PREVOST

WARRANTY BULLETIN

Wb11-05

DATE : JUNE 2011	SECTION :	04 - Exhaust
EXPIRATION: JUNE 2013		
SUBJECT : EXHAUST PIPE ANGLE BRACKET INSPECTION

FIGURE 2: INSTALLATION WITH DDEC SERIES 60

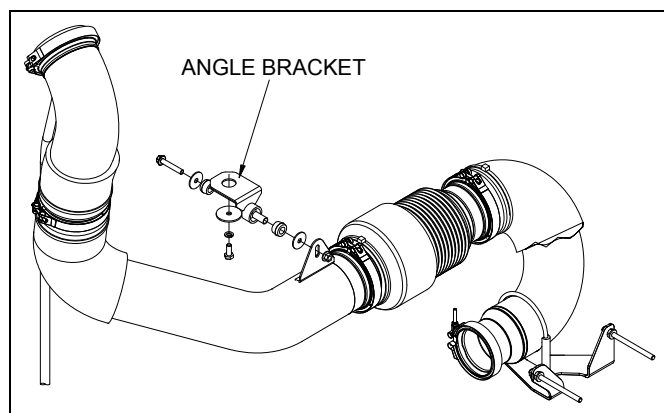
On the vehicles affected by this bulletin, the bolt holding the exhaust pipe angle bracket to the ceiling of the engine compartment may come loose. The exhaust pipe could then start to move and vibrate causing the exhaust pipe to break. Adding a jam nut or replacing the angle bracket if damaged will eliminate the problem and increase the reliability of the installation.

4. Inspect the angle bracket to see if the fixing bolt is missing.
5. If the bolt is present, tighten the bolt and secure the assembly by adding a jam nut  (500847) on top of the nut.

6. If the bolt is missing, install a new bolt  (502804) and secure the assembly by adding a jam nut  (500847) on top of the nut.

7. If the angle bracket is damaged, it can be replaced with the new bracket  (040892).
